Product Change Notice

Design related: minor design change of duplex connector

Duplex Connector AFBR-4526Z

After modification:

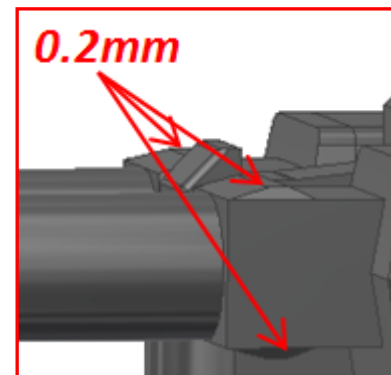
Reduction of ridge-height, details see below pictures. The connector material remains unchanged.

Reduce height of ridges from 0.3mm to 0.2mm

Connector the housing retention force is too high when latch is pressed down. Therefore it is difficult to unplug connector from versatile link housing. The reduction of the thickness reduces the necessary force to unplug the connector.
